## Groupwork

### Technical Note

Project	317 Finchley Road
Title	Planning Note to Support S73 Application
Ref.	240
Rev.	B
Date	13.01.2023

Fig. 4 Proposed façade detail section

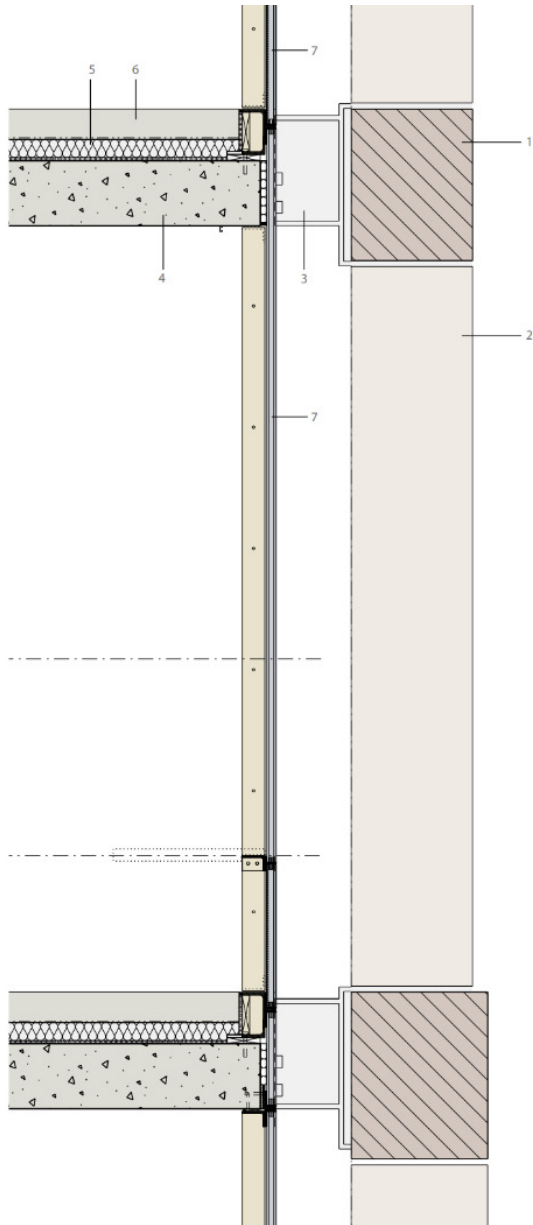
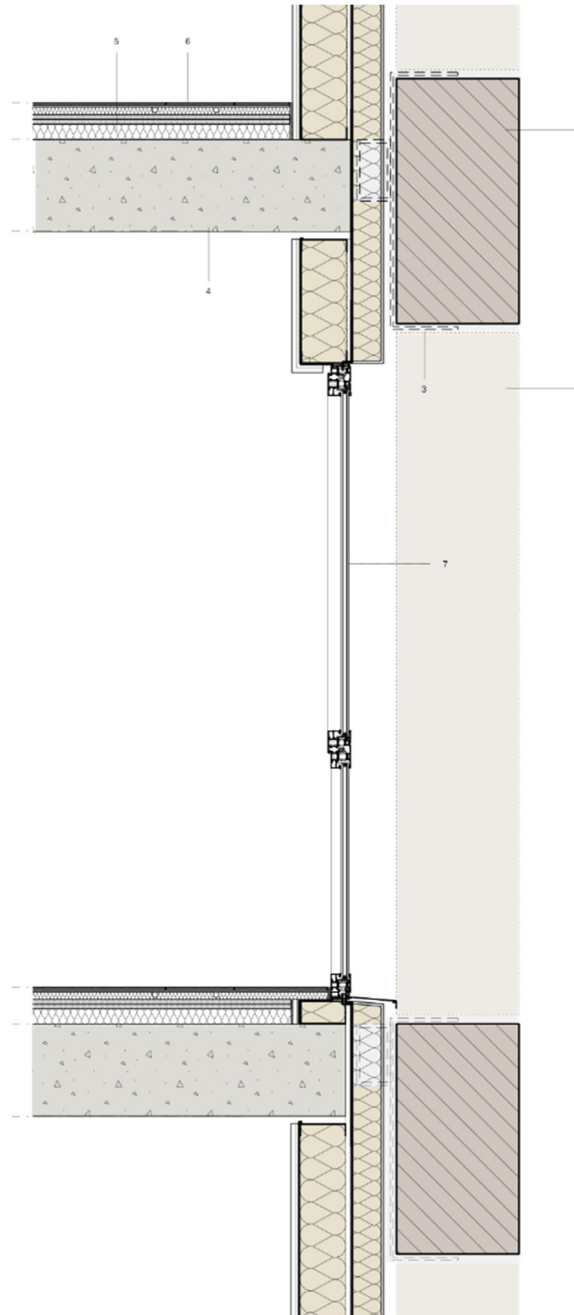
1.1 The external wall system has been adjusted to achieve higher U-Values which will in-turn make for higher quality living conditions and reduce on-going maintenance for the proposed scheme. The wall system proposed is externally finished in a colour pigmented render. The proposed render finish will be colour matched to the structural stone exoskeleton it sits behind which does not deviate from the previously approved wall system colour. The image below demonstrates the similarities in the previously approved finish and the proposed render finish options.

1.2 The proposed external wall system, as seen in fig. 4 below, provides a more robust and durable exterior than the previously approved scheme in fig. 3.

Fig. 6 Proposed Lower Ground floor plan

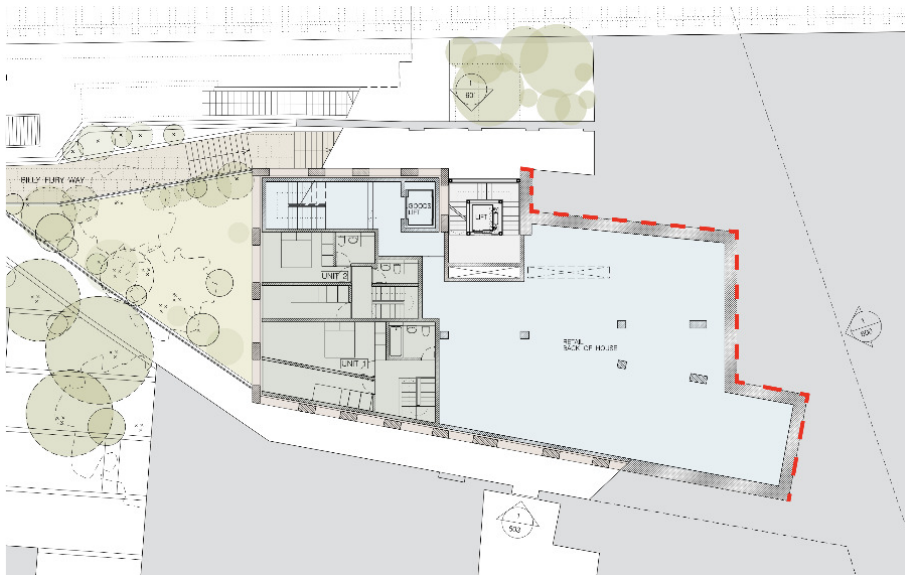
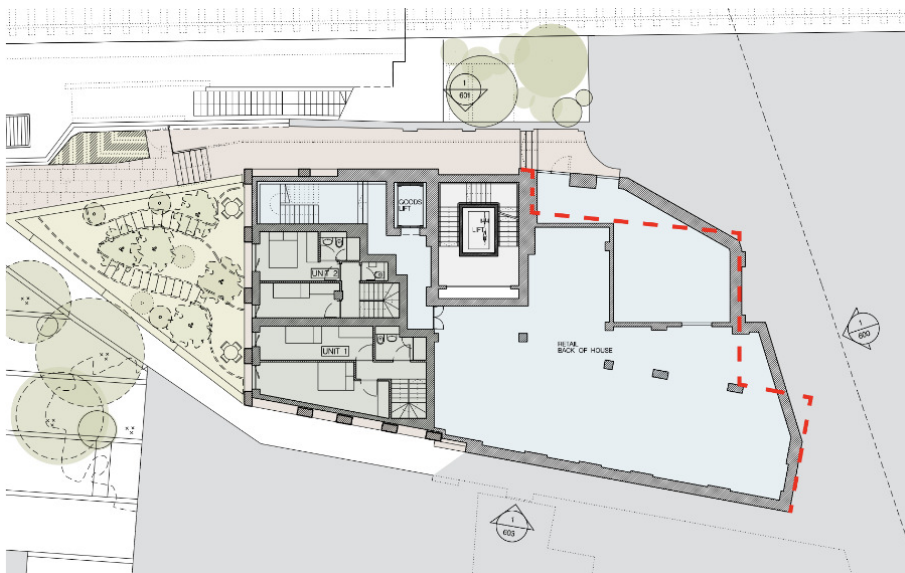
2.1 Development in the scheme's structural performance has enabled us to adjust the basement plan and lower ground plan footprint along the east side as seen highlighted in fig. 5 and fig. 6. With the implementation of the UKPN substation used to distribute electrics throughout the local area, the amended footprint offers a preferable place to store and access the substation safely. Please see the Basement impact assessment J2680-S-RP-0004\_02\_S9 Basement Impact Assessment submitted alongside this Technical note for further details on the effect this adjustment has on its surroundings.

Fig. 8 Proposed Billy Fury Way stair

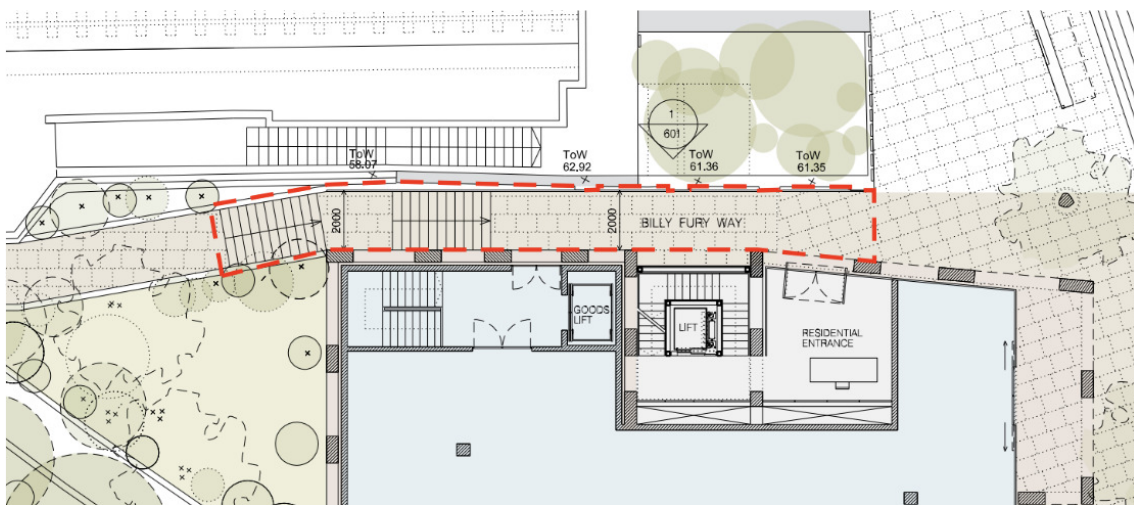
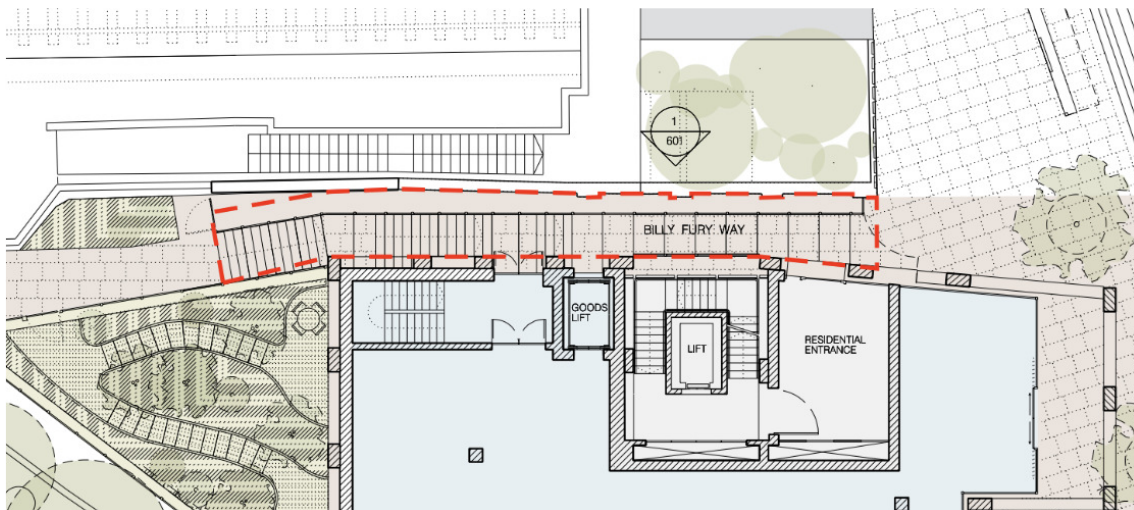
3.1 The Billy Fury Way staircase has been adjusted to minimise the impact on the wall to the north of the site which is shared with the train station. To achieve this the proposed Billy Fury Way stair will be fixed and supported from the proposed reinforced concrete walls of the Lower ground and sits independent of any existing structures. This proposal provides access to the UKPN substation within regulations. The proposed stair has minimal effect on the previously approved scheme by maintaining the same finishing tile as the surrounding area and the previously approved stair. This can be seen below in figs 7 and 8.

Fig. 10 Proposed slanted stone columns

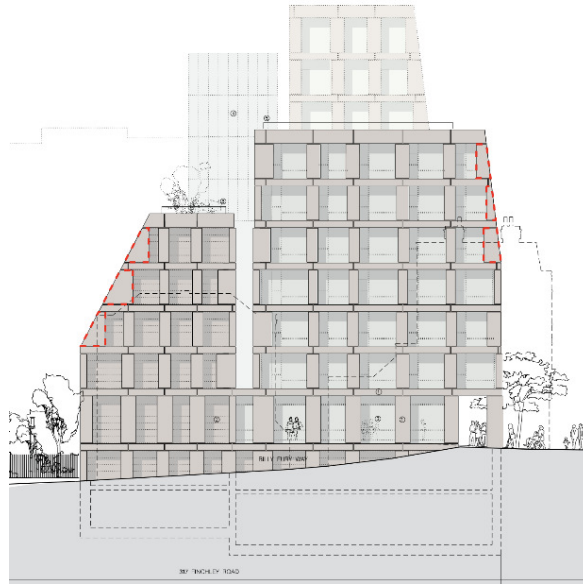
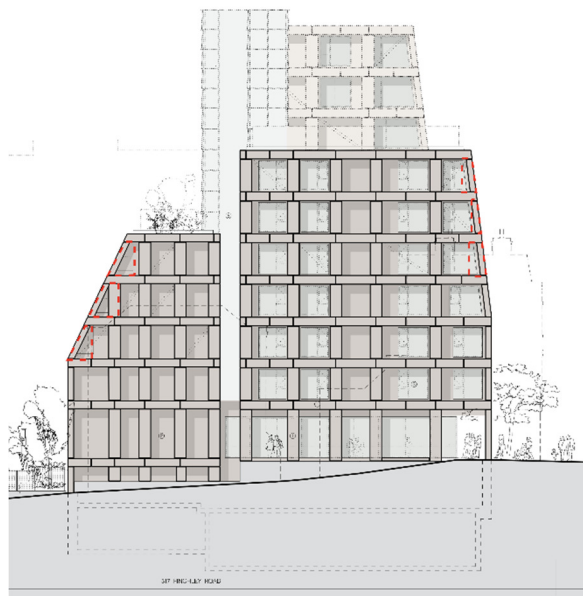
4.1 Minor refinements to stone column and lintel dimensions are proposed as part of the minor material amendment. The slanted stone columns as highlighted in fig. 10 are proposed in a similar geometry to the column and lintels across the planning approved scheme in fig. 9. This simplifies the installation on site and the manufacturing process resulting in less material wastage.

Fig. 12 Proposed stair core glazing composition

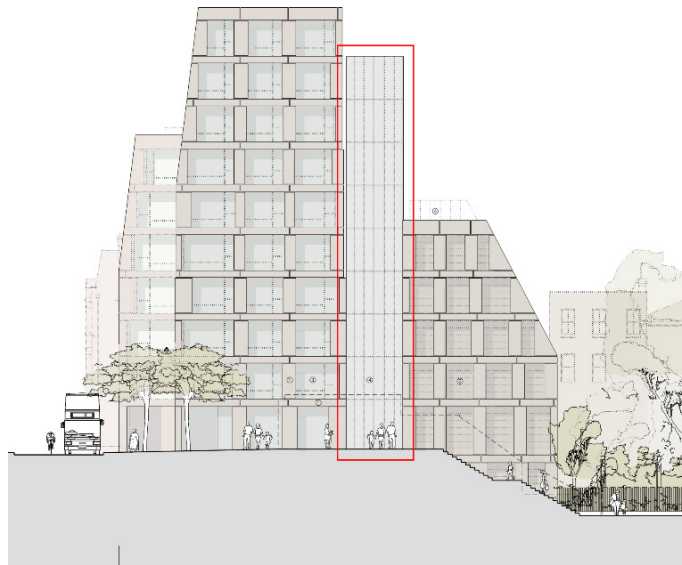
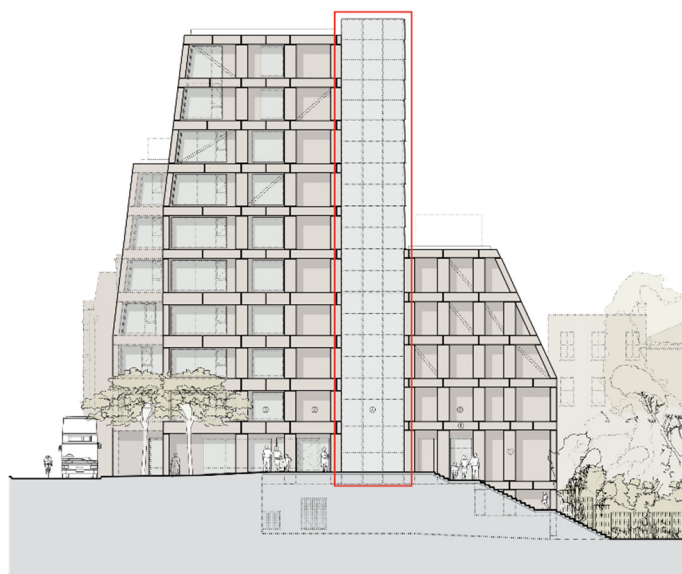
5.1 The composition of glazing has been altered on the stair-core to follow similar proportions of the glazing throughout the rest of the planning approved scheme, forming a more cohesive design. The stair core glazed facade is stepped and lapped to allow natural through-ventilation. Single glazed panel raised to form balustrade to the staircase roof for maintenance and access to the smoke ventilation equipment installed to meet current fire regulations.

Fig. 13 Proposed structural steel bracing elevation

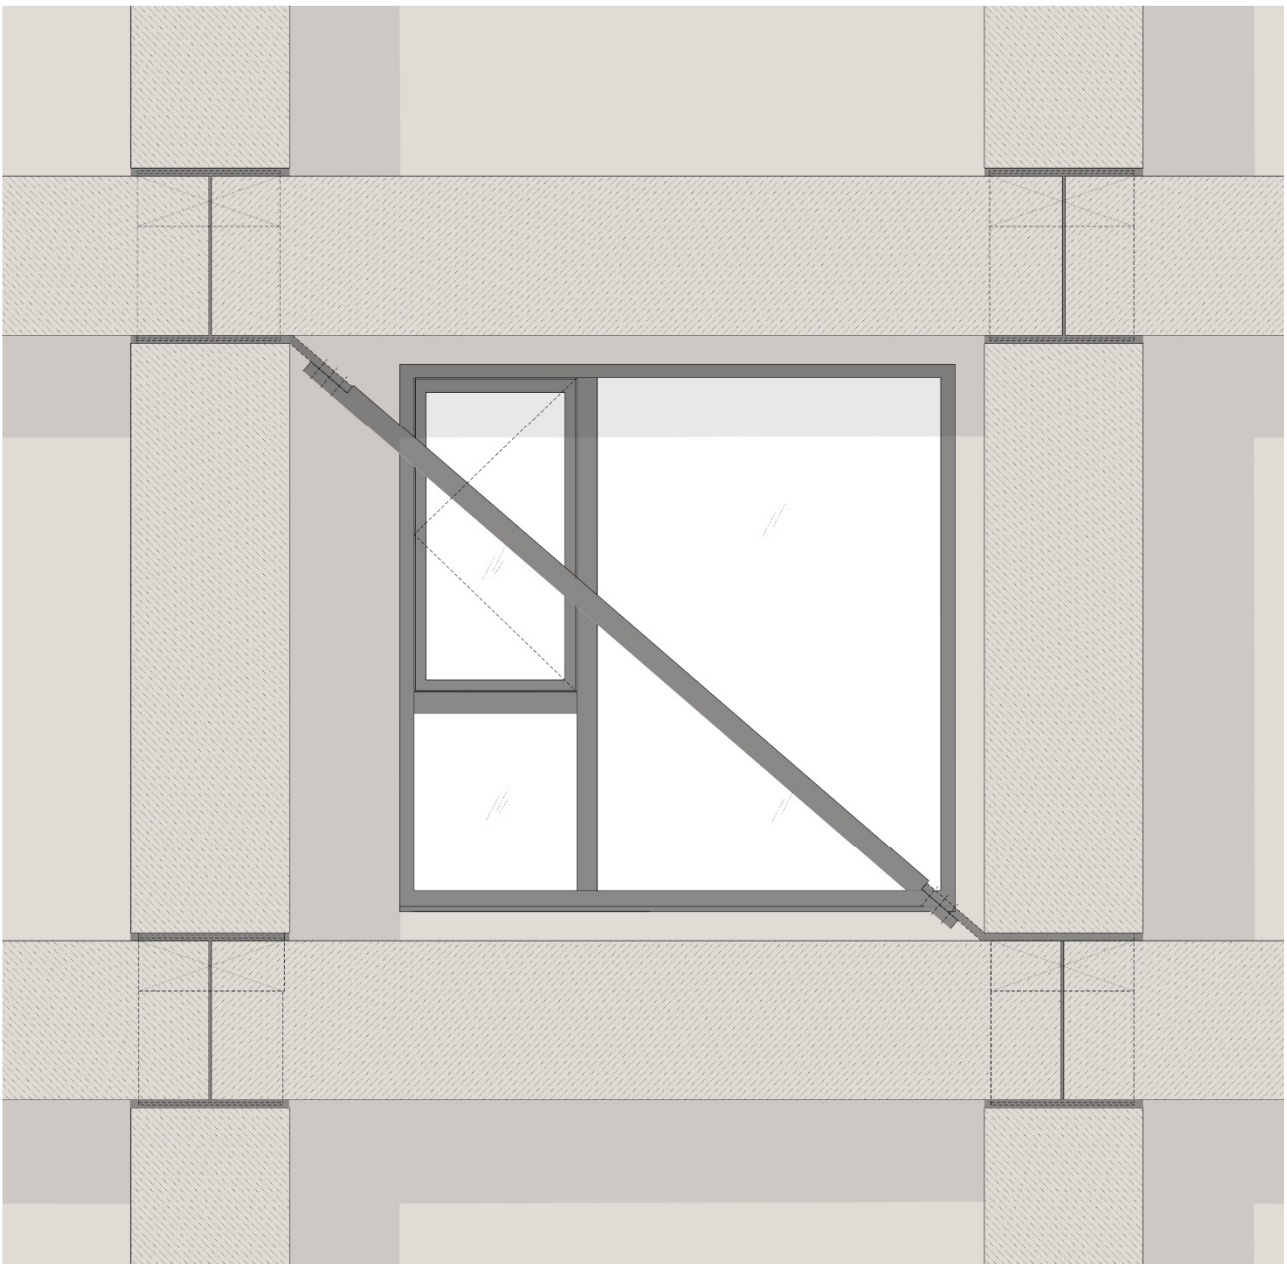
6.1 By introducing occasional steel bracings we've been enabled further refinement in the stone exoskeleton. This enables the slimming of stone columns and further emphasises the planning approved scheme of expressing the structure externally. The bracings will be colour matched to surrounding metalwork. The minimal impact of the steel bracings can be seen in fig. 13.

Fig. 15 Proposed typical floor plan

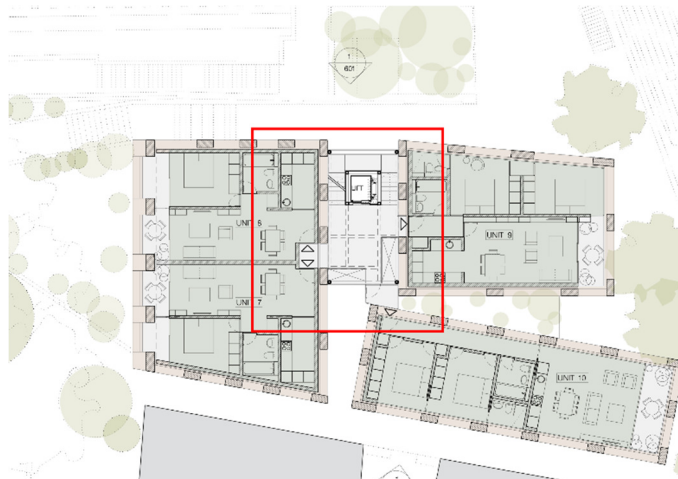
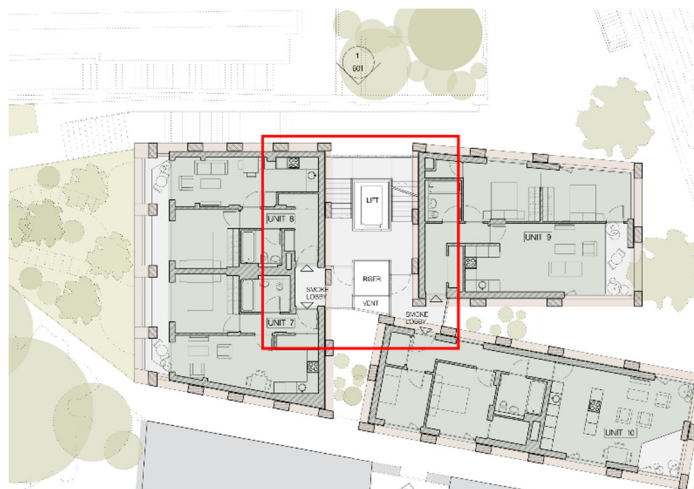
7.1 Further to LFB consultation request have been made to upgrade the scheme to meet current fire regulations. Summary below of changes which have been introduced, please read in conjunction to Hydrock Fire Strategy/ Technical note:

- Mechanical smoke ventilation shaft incorporated with minimum 0.6m<sup>2</sup> free area and AOV within each lobby.
- Smoke lobbies to all floors incorporated to separate/protect the main stair from the apartments.
- Plant associated with the smoke ventilation + generator have been located on the main staircore roof.
- Sprinklers and LD1 detection introduced to all apartments.
